TECHNICAL INFORMATION

SUBJECT: Auto-oiler assembly on **ECHO CS-2511TES, shindaiwa 251TCs and 251Ts**

Number: Y2017-633
Issued: Aug. 31, 2017

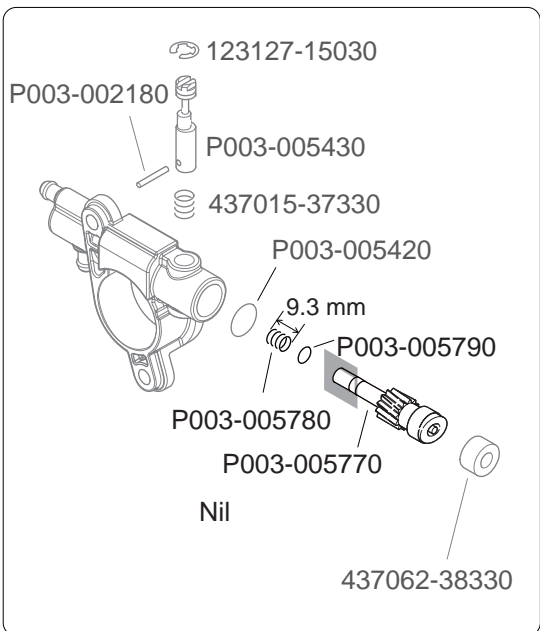
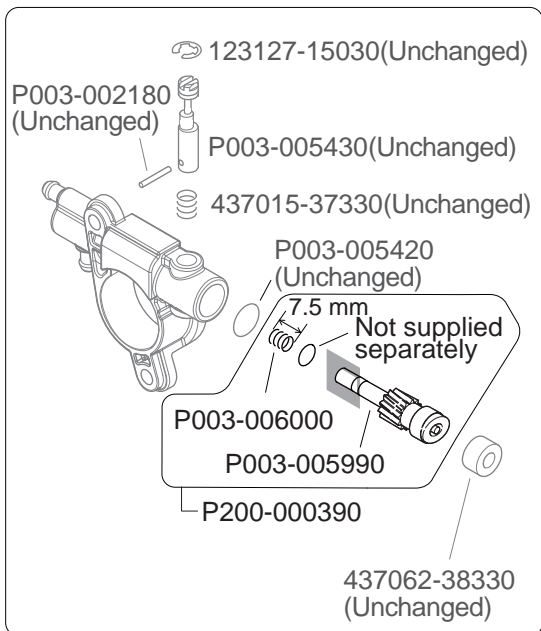
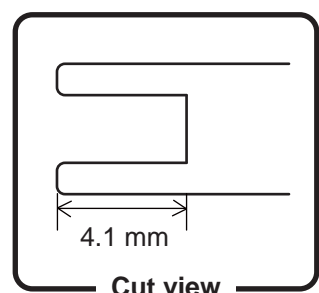
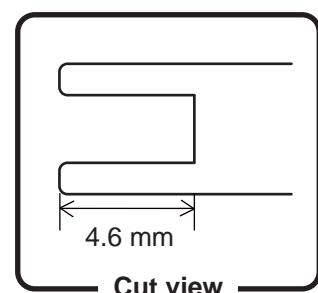
Washer, spring and plunger gear are changed to prevent spring from wearing early.

CS-2511TES	Serial Number 37047387 and before	Serial Number 37047388 and after
251TCs	Serial Number 37007680 and before	Serial Number 37007681 and after
251Ts	Serial Number 37007220 and before	Serial Number 37007221 and after
Ring Spring pin Needle Spring Washer Washer Spring Plunger gear Plunger gear kit Oil tank cap Auto-oiler assembly	 <p style="text-align: center;">C022-000210 (OP-27A)</p>	 <p style="text-align: center;">C022-000211 (OP-27B)</p>
	 <p style="text-align: center;">Cut view</p>	 <p style="text-align: center;">Cut view</p> <p>Auto-oiler assembly C022-000210 can be replaced with C022-000211. Washer P003-005790 can be replaced with Plunger gear kit P200-000390. Spring P003-005780 can be replaced with Plunger gear kit P200-000390. Plunger gear P003-005770 can be replaced with Plunger gear kit P200-000390. The parts before change and after change are not interchangeable independently.</p>
